**SAN ANTONIO WATER SYSTEM
MULTIPLE SEWERSHED PACKAGE 2A
SAWS PROJECT NO. 17-4533
SOLICITATION NO. CO-00146**

**ADDENDUM 4
August 29, 2018**

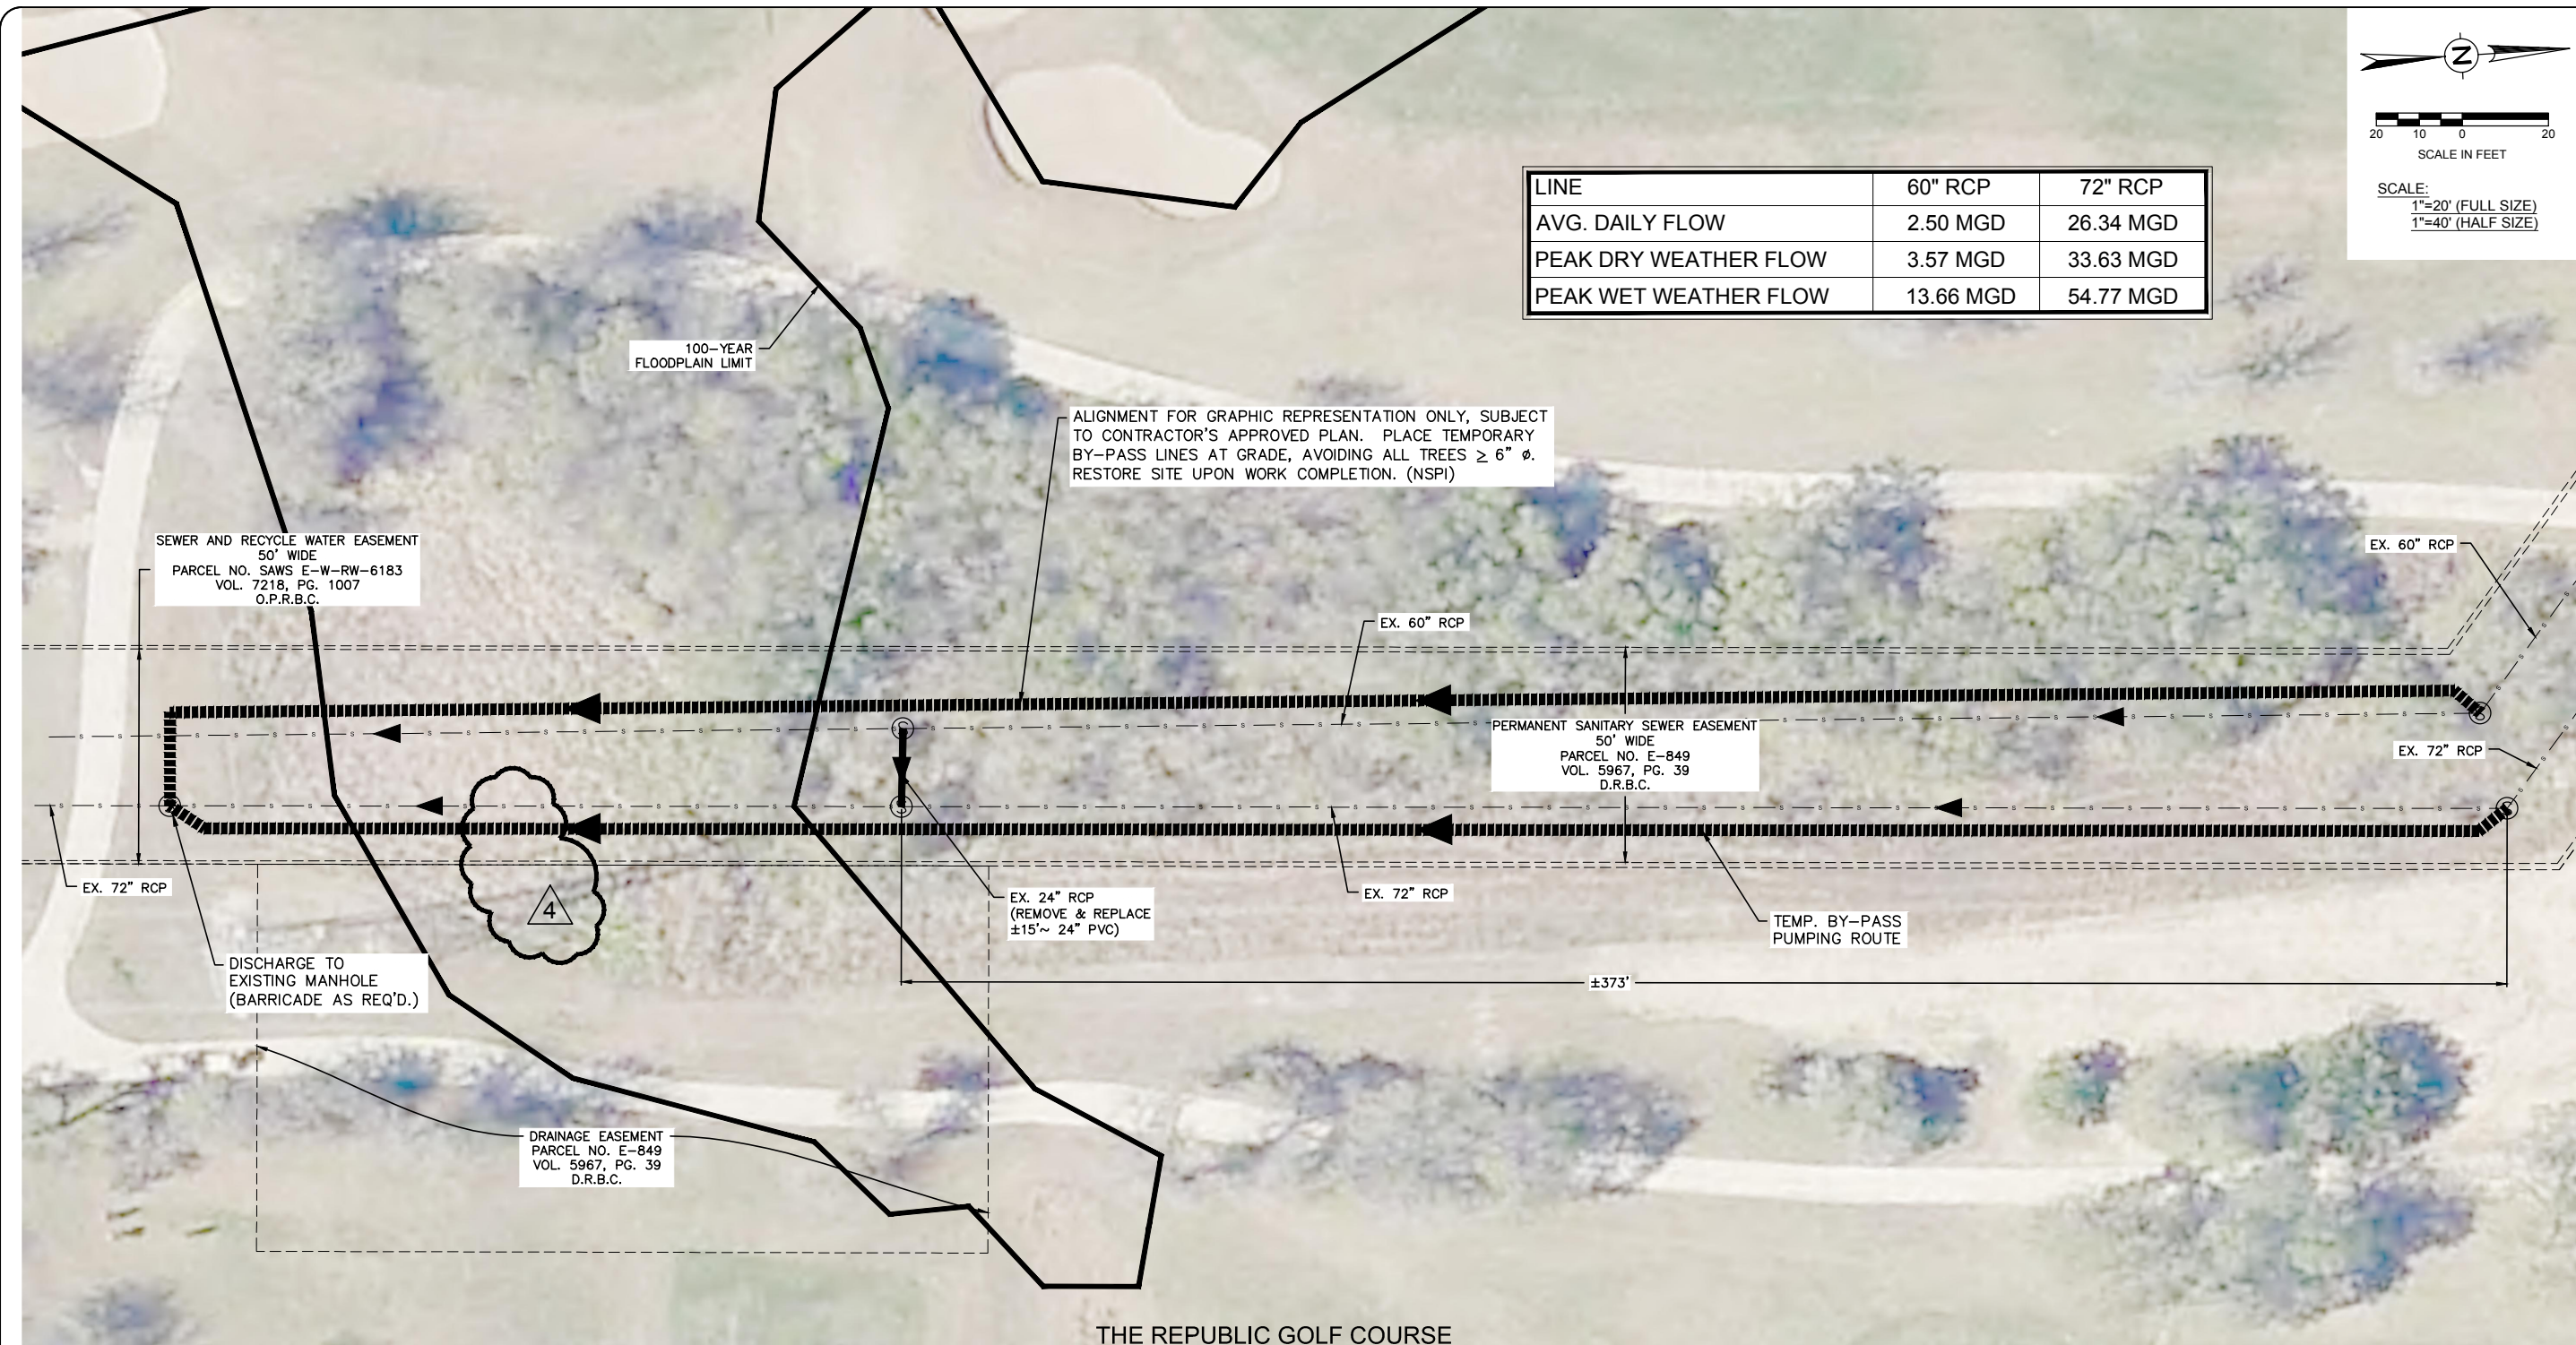
Q47: In reference to drawing # P-33, will the Owner please provide slopes of the existing 48", 60" and 72" diameter RCP lines?

- Sheet P-33: Remove and replace Plan Sheet P-33 with the revised Plan Sheet P-33 attached to this Addendum. Incorrect reference to '48" RCP Siphon Main' has been deleted.

Response: Refer to Modifications to the Plans in this Addendum. Slope of the 60" and 72" RCP lines is approximately 0.1%. The 48" line shown is in error, and has been removed from updated Sheet P-33 included herewith.

F:\2017\117069 SAWS 2017 Pipeline Engr. W0 Contract\117069.02 - Multiple Sewershed Package 2\Civil 3D\Drawings\Engineer\117069-Slide Gate Details.dwg

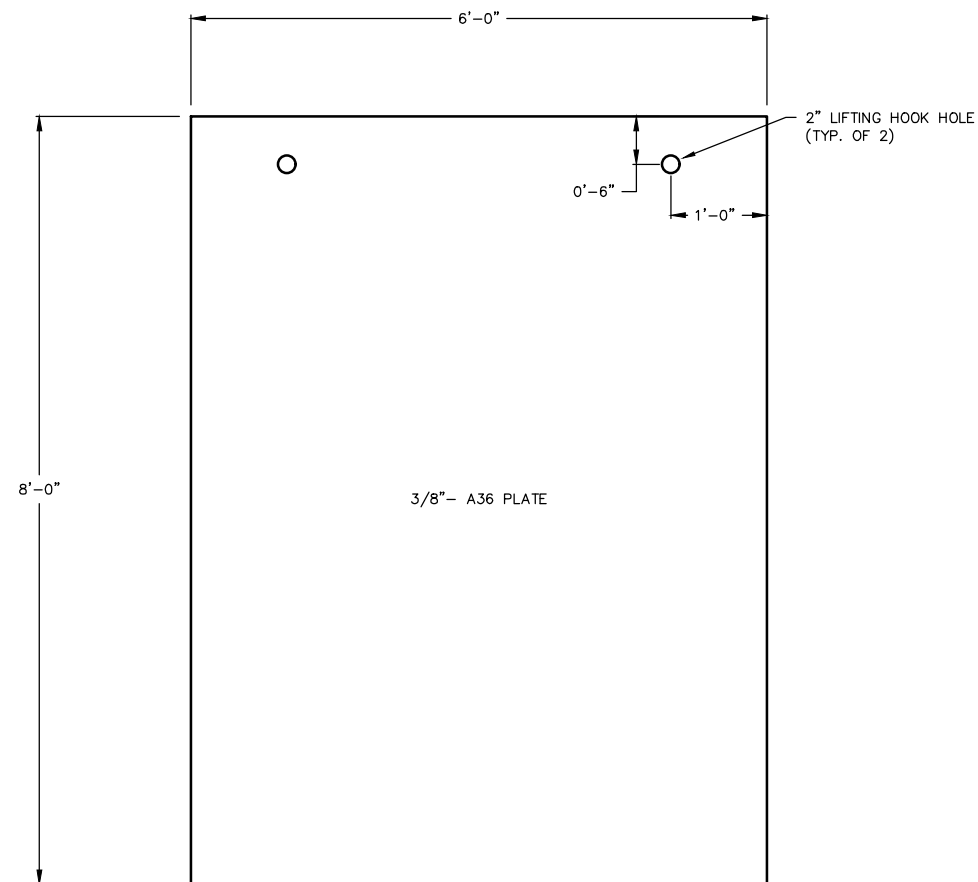
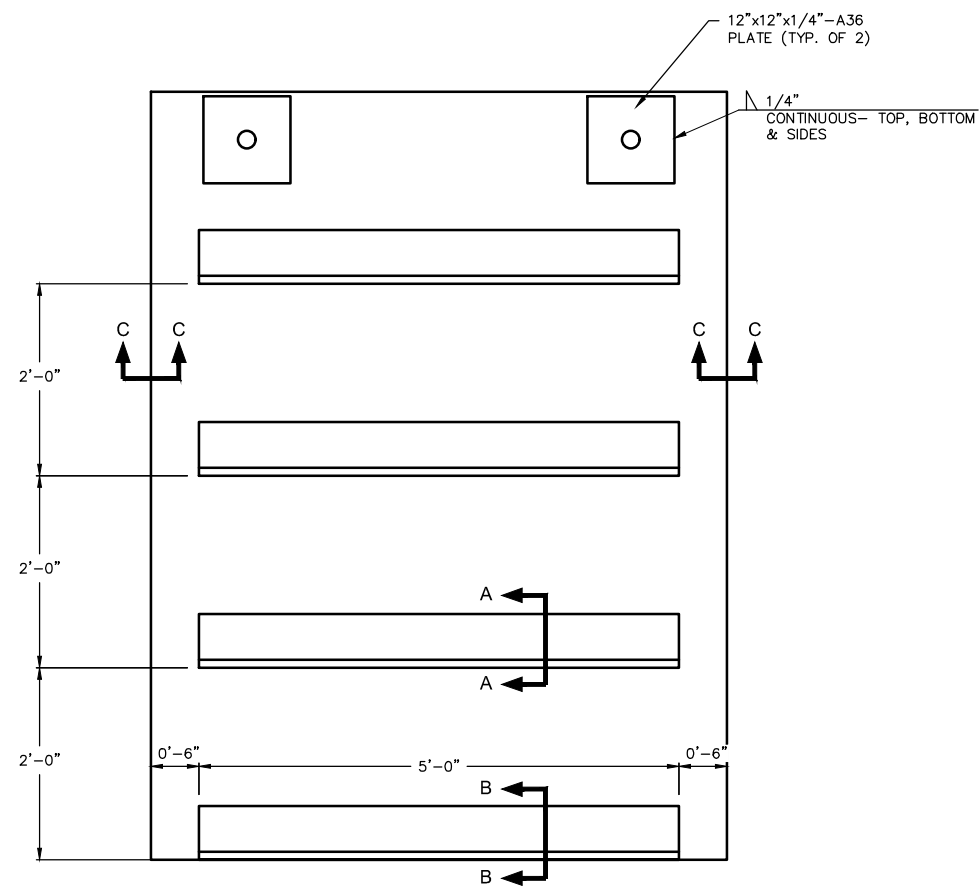
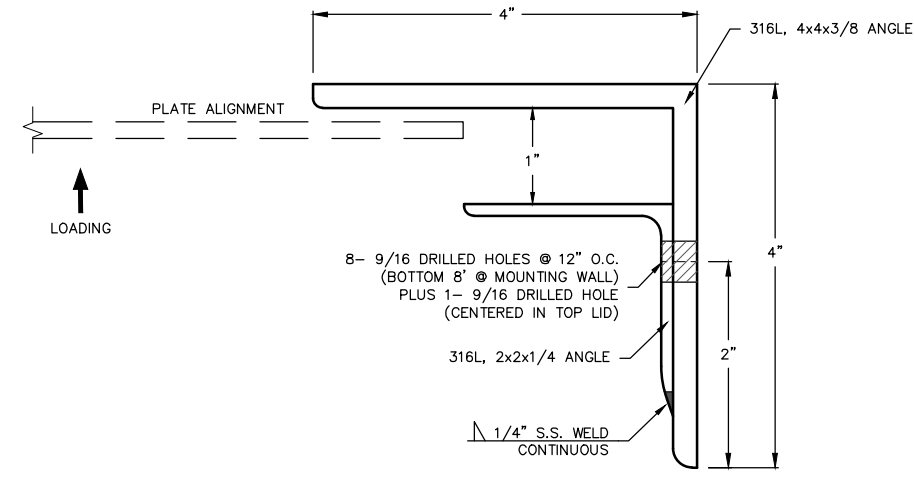
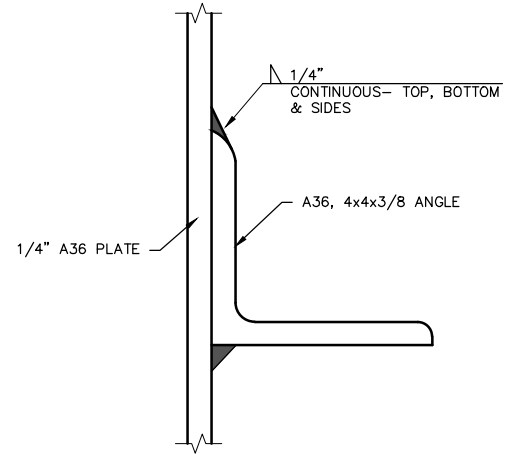
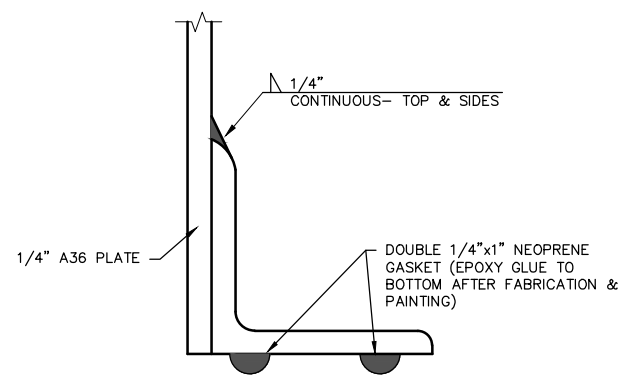
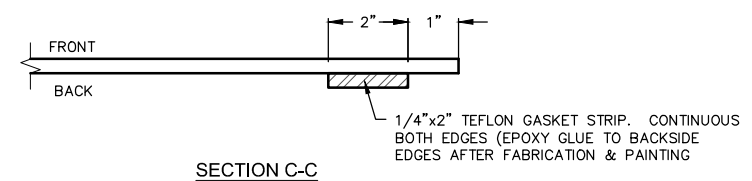
Q25: Note 3 on drawing P-51B calls for the removable slide gates to be primed and coated with a Tnemec epoxy, but there is no mention of which Tnemec epoxy is required, and from the Tnemec website, there are numerous different Tnemec products available. Please provide the Tnemec "series" of epoxy required – a "series" is comprised of numbers that describe what type it is. Also, what specifically does "0.6 mil min each coat" mean? Is this a typo? Usually two (2) coats of 4-6 mils is required, not .6 mil. Please clarify.

- Sheet P-51B: Remove and replace Plan Sheet P-51B with the revised Plan Sheet P-51B attached to this Addendum. Sheet Note No. 3 has been revised to clarify two 6-mil coats of Tnemec Series 22 Epoxoline.

Response: Refer to Modifications to the Plans in this Addendum. Plan Sheet P-51B has been updated to clarify 6 mils per coat of Tnemec, Series 22 Epoxoline, or approved equal
